**LIST OF PERSONS, ORGANIZATIONS, AND PUBLIC AGENCIES
THAT COMMENTED ON THE DRAFT ENVIRONMENTAL IMPACT REPORT (EIR)**

**Subject: Draft Environmental Impact Report (EIR/SCH No. 2005121098),
General Plan Amendment (GPA 05-010), Specific Plan (SP03-003) and
Draft Habitat Loss Permit (HLP) for the Sugarbush Residential
Development Project, County of San Diego, California
(TM 5295RPL, Log No. 02-08-047)**

ATTACHMENT TO LETTER B, RESPONSE B5

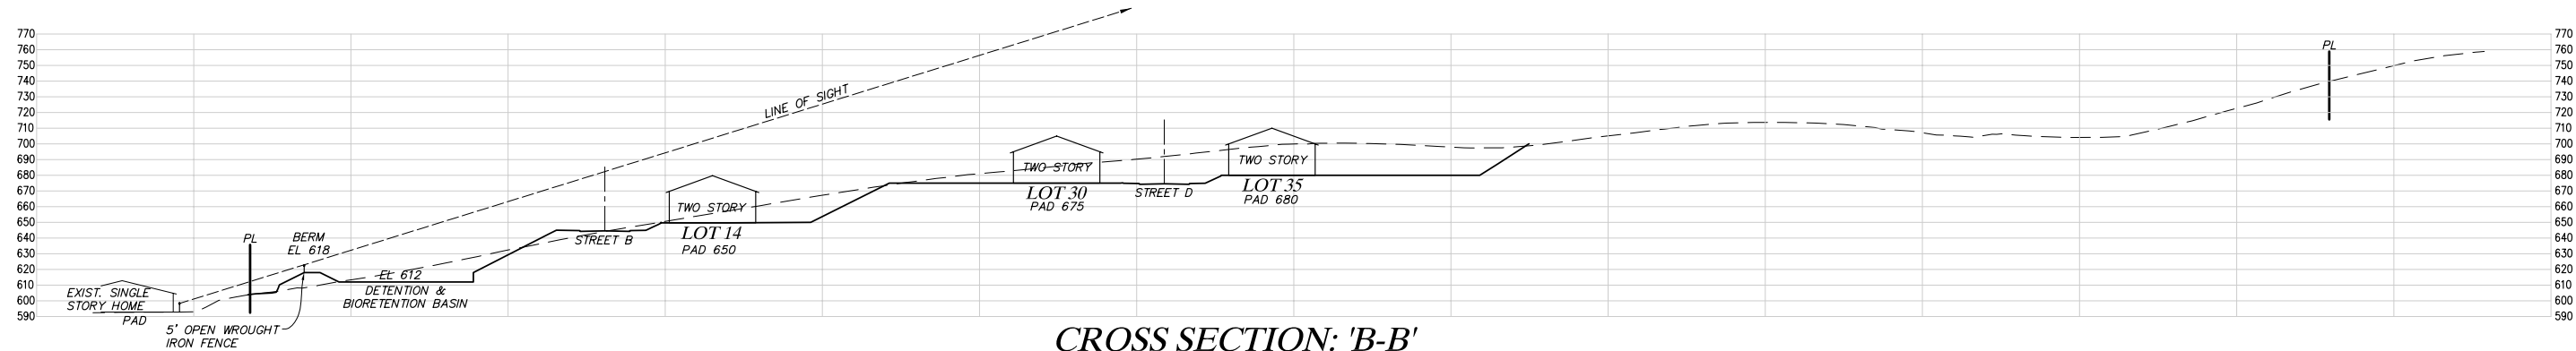
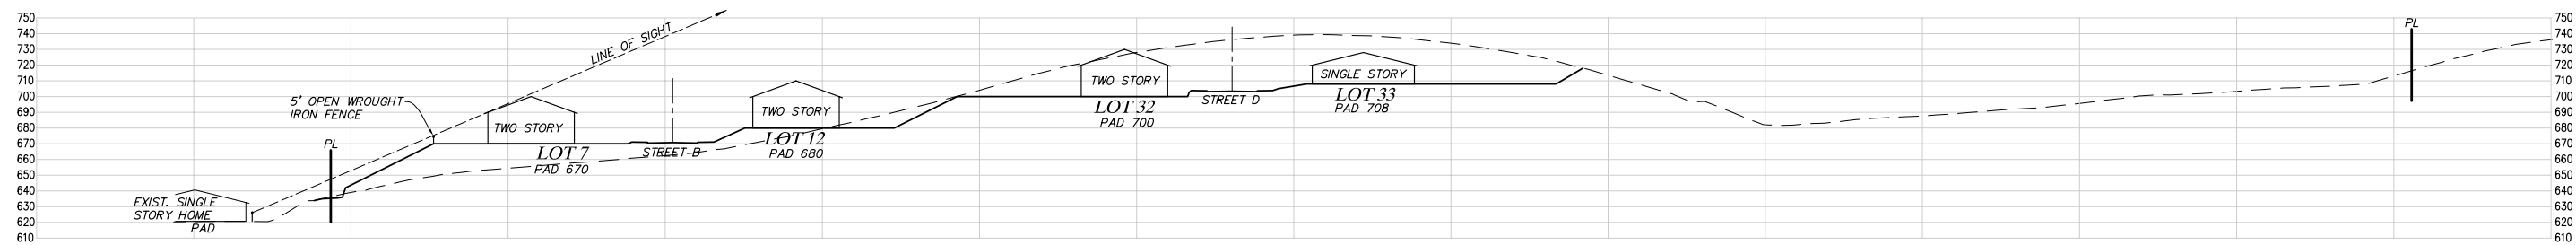
Comment 16: Although the Aesthetics show the project boundary from various points there are no photo simulations to show project massing on the site. No plans, elevations, or story poles have been made available for the public so that they could adequately see the visual impact of the project. With 421 views being impacted, shouldn't more realistic simulations be supplied to adequately show the full impact of the project on Aesthetics and how mitigation measures will address those impacts?

B25. The cross-sections provided in the Draft EIR (Figures 2.1-8 and 2.1-9A and B) bisect the Project property north-south and east-west. The primary purpose of the cross-sections was to provide the reader with an understanding of the Proposed Project's grading relative to the existing landform on site. In response to the comment, however, additional cross sections have been prepared and are attached to this response.

These cross sections depict three east-west sections through lots 3, 17, 27 and 39; E, 14, 30 and 35; and 7, 12, 32 and 33. As requested, the relative scale and location of abutting off-site structures are indicated, as is the portion of the on-site open space slope to the east. Note that single-story structures are shown on lots 17 and 27 while two-story homes are shown for each of the lots closest to the western property line. Specific development plans are not completed, so--

with the exception of lots for which a single-story dwelling is required as part of the Project Fire Protection Plan--final home elevations on each of the lots (i.e., one or two stories) may vary from that shown. They are indicative, however, of planned variation in structure height that would occur within the development. Note also that the cross sections do not reflect full potential screening provided by enhanced (in terms of density and maturity) slope planting that is required as Project mitigation. This planting is likely to exceed the five-foot fencing placed at top of slope along the proposed residential lots, but sight interruption is only assumed for the five-foot fence height.

As can be seen from the cross sections, the most conservative (i.e., potentially greatest visual effect) structure type is shown next to abutting off-site viewers. This is because the homes depicted are two story and are placed immediately adjacent to the Applicant-extended 100-foot setback from the property line. Even with these assumptions, the typical lines-of-sight depicted here show that views from some of the eight immediately abutting homes would not encompass the proposed structures on the abutting Sugarbush lots. For one of the depicted cross sections, topography would intervene. For the northern-most typical cross section, a straight line shows that the viewer potentially would have a view to the second story of the Sugarbush structure. Slope planting required of the Project as mitigation, however, would be likely to obscure at least part of the residence as well. If the structure were to be moved easterly on the pad, only a portion of roofline could be visible (which, again, most likely would be obscured by the required slope planting). For the southern-most typical cross section, the sight line shows that the viewer potentially would have a view to a portion of the roof top of the Sugarbush structure. Slope planting required of the Project as mitigation, however, would be likely to obscure at least part of the roof top as well. Also as indicated by the cross sections, the more easterly homes within the Proposed Project also would be shielded from views from the west.
